Correspondence received ahead of the August 15, 2024 Unincorporated San Mateo County Bicycle and Pedestrian Advisory Committee Meeting From: Janet Davis

Subject: BPAC - Agenda Item 12 - Santa Cruz/Alameda Project

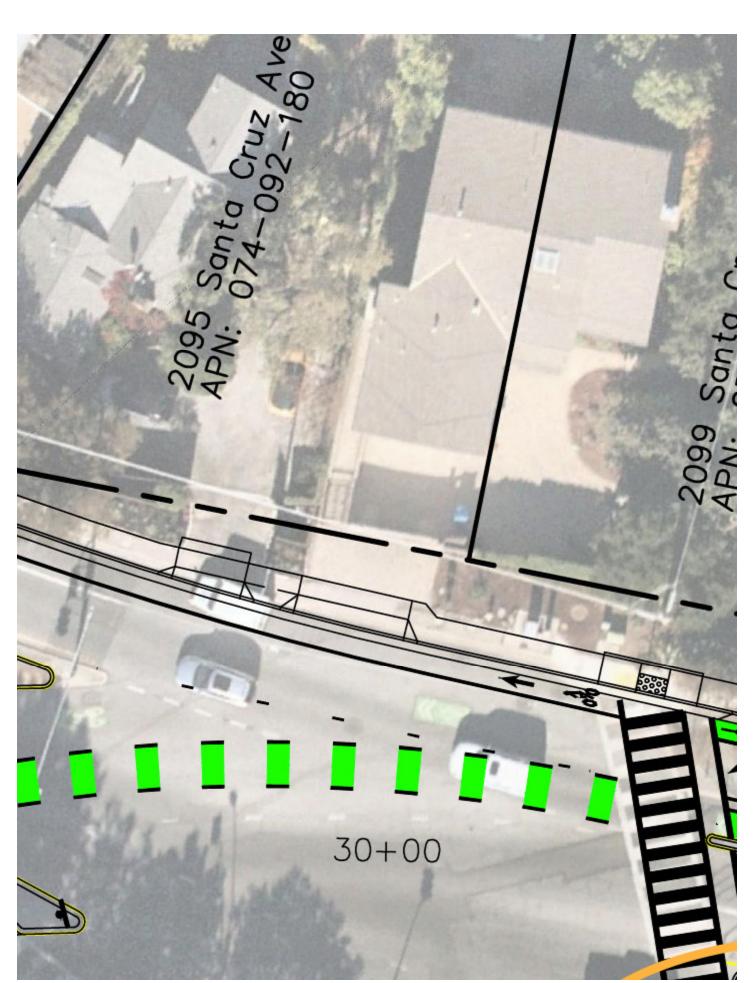
One of the key locations that issues were identified is the NB Bike Merge area at the "Y". The design plan DPW has, puts key stakeholders at risk:

- **Residents** at the "Y" access to/from properties is severely impacted and sightlines are reduced; there is no provision for trash and recycling nor postal delivery that doesn't create a danger to cyclists and pedestrians.

- **Pedestrians** have traffic pushed next to the sidewalk and have extremely long and angled crosswalks that not only have visibility issues but also require pedestrians to be in the roadway significantly longer when crossing;

- Cyclists (northbound) are required to use a bike merge design that is at the very most chaotic point in roadway
 (in all of south county)n- where 10,000 cars a day have to negotiate the Y and avoid 8" high medians. Adding to
 this confusion and danger is that the NB Santa Cruz lane for cars is sandwiched between a newly formed bike
 lane for Alameda and a bufferless bilke lane for Santa Cruz.

- **Utilities**: This location is a major service hub for virtually everything: Electrical, cable, traffic control, water, gas, and sewer these all require parking for the frequent work the occurs here.

The following illustrations are not meant to be final engineering drawings, nor are they at exact scale, although they are using the design base DPW gave us and are close enough to validate concept within the given right of way. They serve as a means to get the community's concepts and objectives across and hopefully will allow for changes to make this a smoother and safer roadway. The community alternative is pedestrian and cycling safety centric. It does a much better job of improving safety and reducing risks than the DPW design. That goal, along with protections for residential safe access, is what this project was originally about.

I am sure there would be changes, yet this community's suggestion of having high visibility on the road (green) and a longer merge area will make motorists much more aware that bikes are merging and allowed to share the road more safely. This should, and I think will, help slow traffic speeds, especially when cyclists are in the mix. Eliminating the extra weird bike lane in the current DPW design by making the merge longer, also reduces confusion and gets rid of the dangerous "bike sandwich" that was designed where the NB Santa Cruz vehicle lane has bike lanes on each side and one of the bike lanes has no bike buffer.

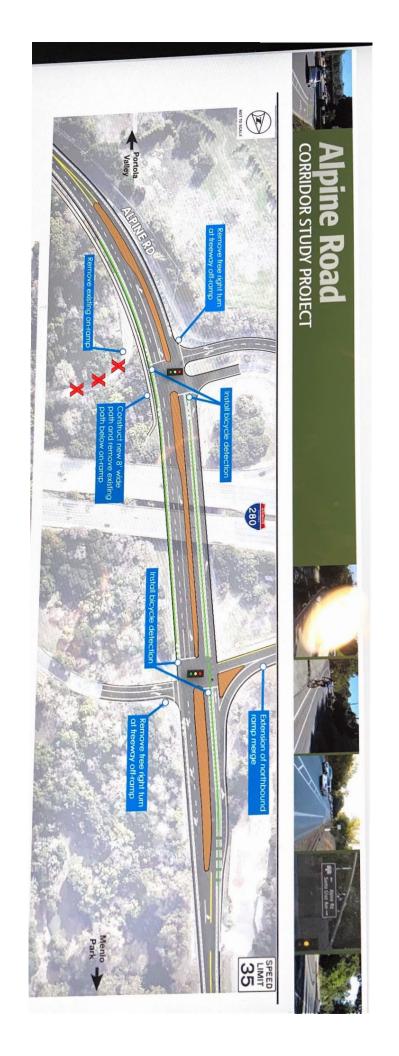
Although I believe the current configuration to be adequate from a cycling perspective, the proposed signalised design is Ok, too. The proposed signalised design gets rid of some turning motions for motorists that potentially interferes with the path for cyclists. Improvement to the design would include further tightening of turns for motorists. However, I would recommend that the configuration be that of Figure on page ES-11 of the Alpine rd study that was completed in 2017-18 interval. It has a much cleaner design for the buffered bike lanes (I shall try to attach a figure to this email, iPad limited, though). The configuration distributed for this meeting has some "odd" crossings for the bike lanes at the ramps to the freeway.

One question that I have is how these two proposals will modify the existing Alpine trail which is heavily used by pedestrians and novice cyclists.

In the support letter, I strongly suggest that the BPAC reject the roundabout proposal. Plus, recommend the configuration in Figure E3 of the Alpine rd study report.
